Hydrogeology

HOC/00106/0036

The Wendover Green Tunnel and North Cutting have a similar impact to 'building' a new chalk stream south of Wendover.

HOC/00106/0037

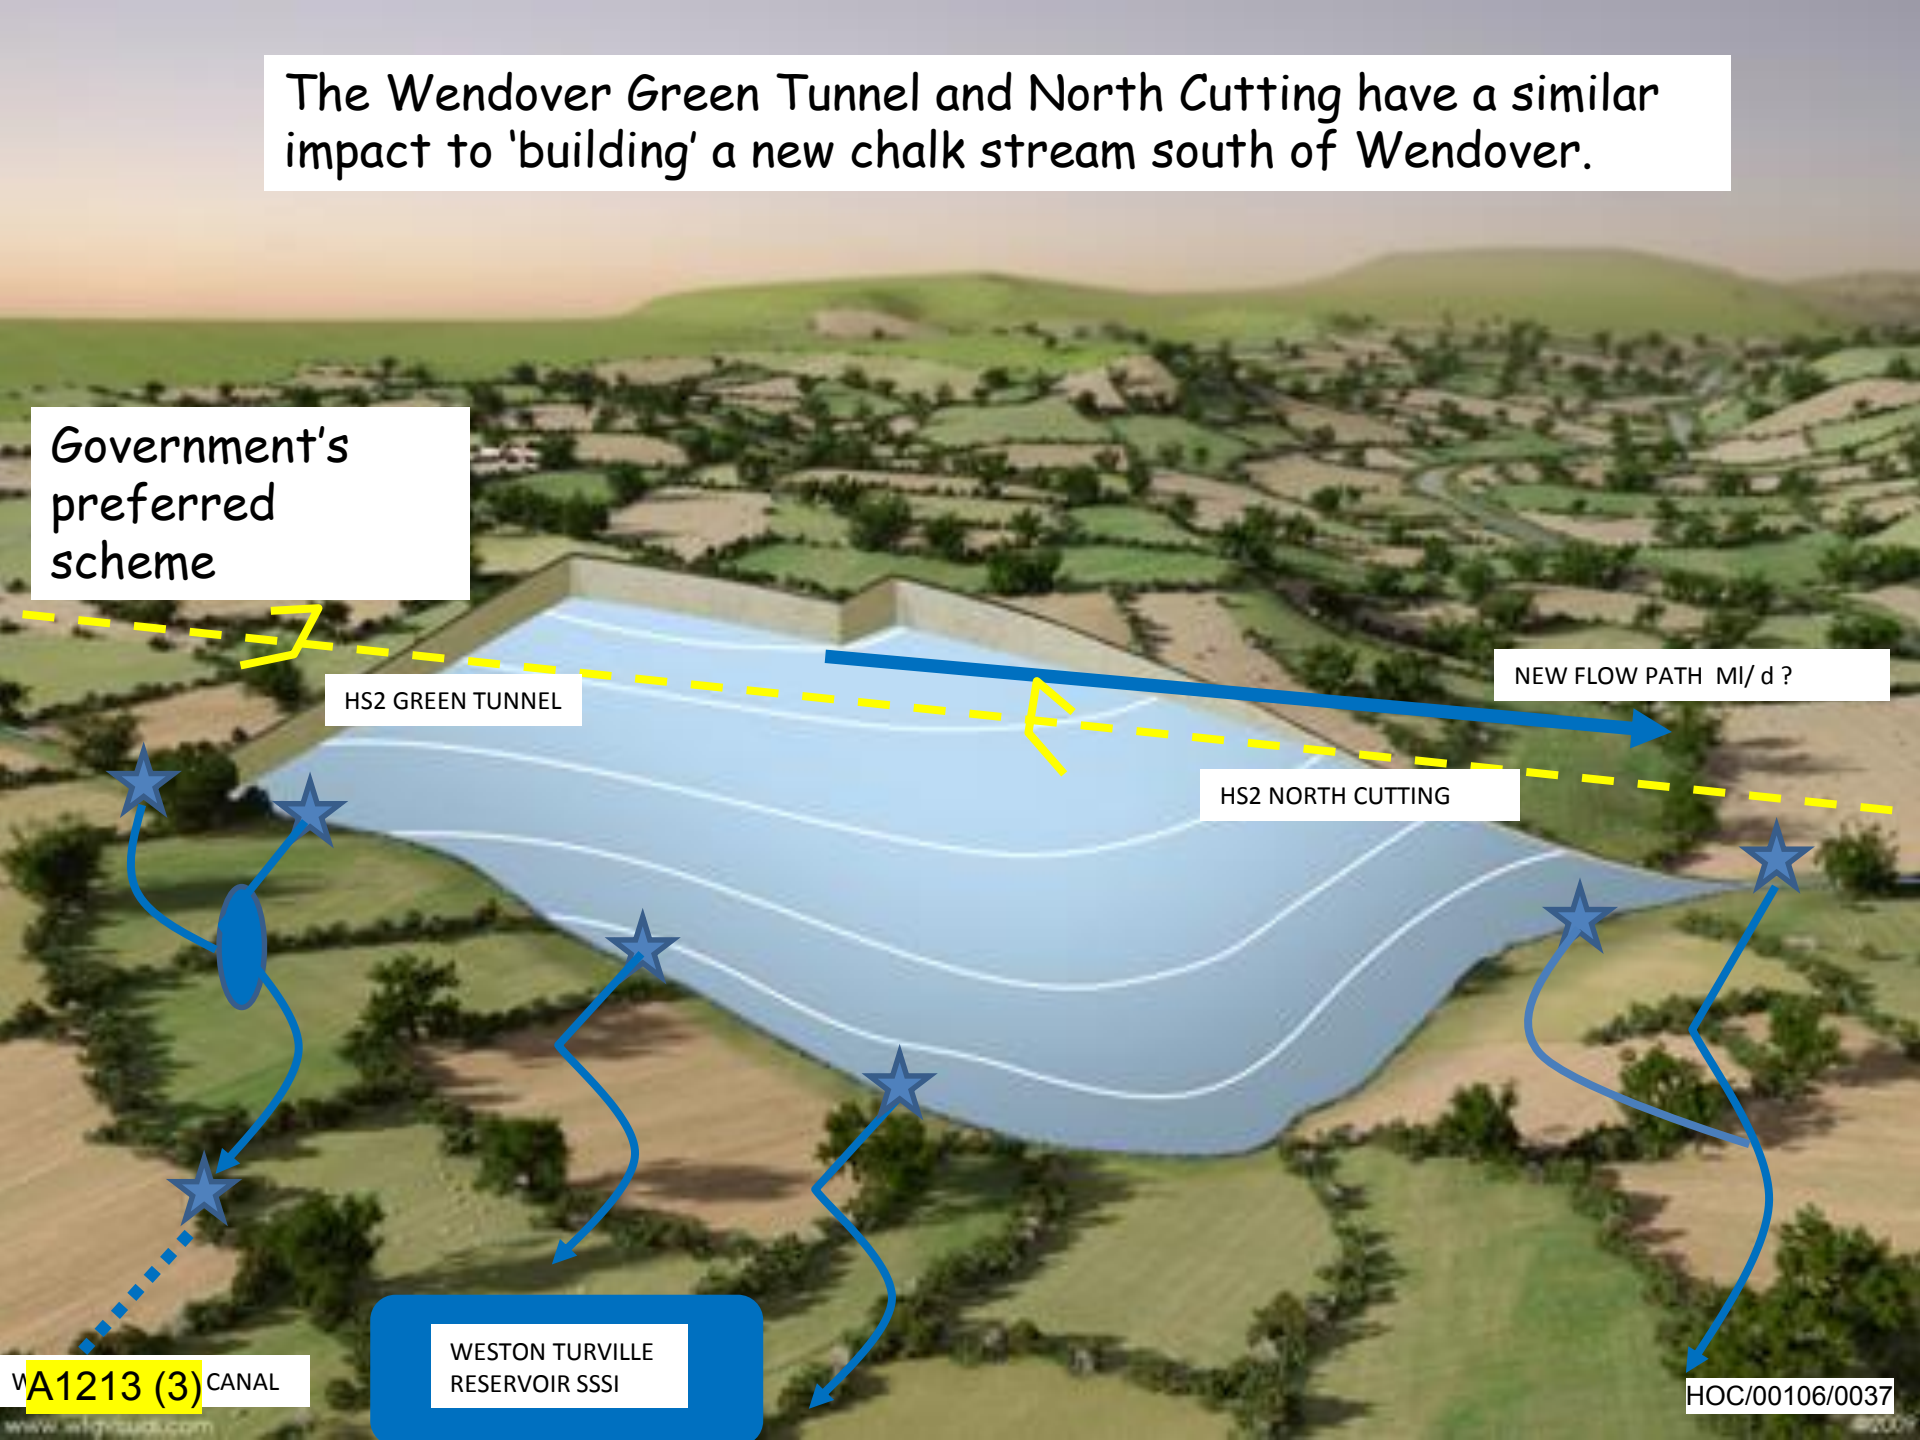
NEW FLOW PATH MI/d ?

5.2.8 The inferred water table elevations under normal conditions and the route are compared on Figure 3 and Figure 4.

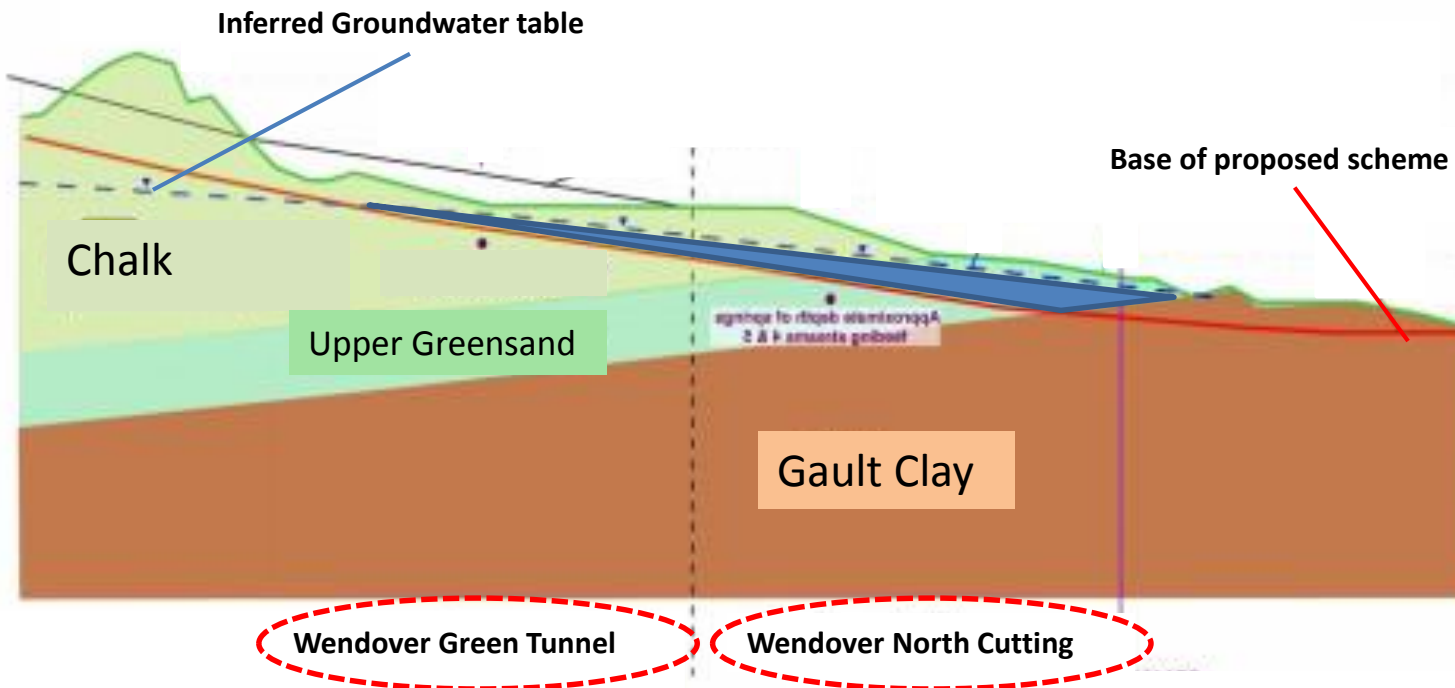
DfT identify that Wendover Green Tunnel (WGT) & Wendover North Cutting (WNC) will be excavated below "normal" groundwater level.

DfT methodology contains one omission & four mistakes,

➤ No estimate of the flow intercepted.

- Sichardt's formula for identifying the zone of influence for flow impacts.
- Spring catchments define whether flows will be impacted by WGT/WNC.
- Flow impacts only occur down gradient.
- The depth of aquifer below the base of the WGT/WNC has an effect on the flow impact.

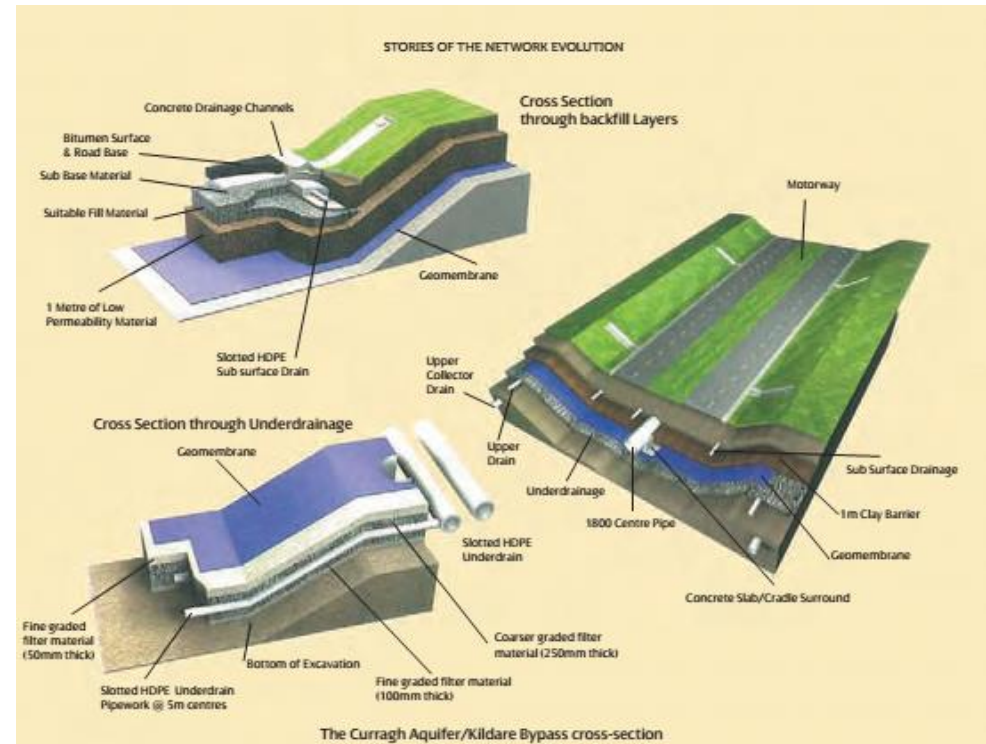
What about when GW levels are at their maximum?

- Ref. Groundwater Flooding in Buckinghamshire Document Number: C252-ETM-EV-NOT-020-000017
- Will the pumping station be able to cope?
- It may not be possible to mitigate this?

Figure 6 - Schematic representation of impact of proposed cutting on groundwater flooding without mitigation

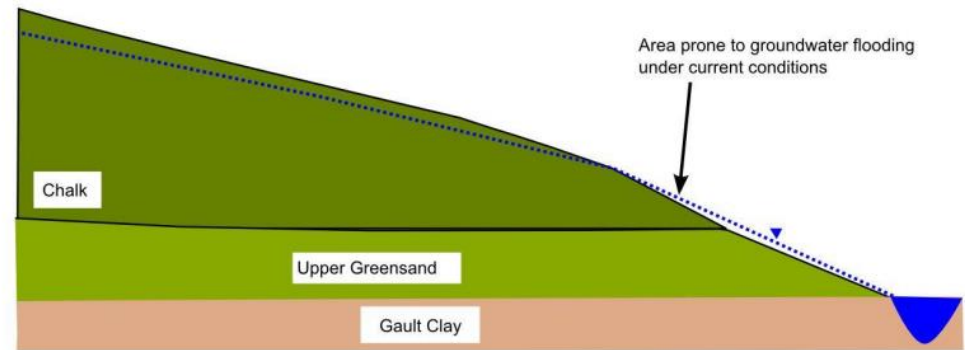
Engineers can always come up with mitigation measures but ... (Kildare)
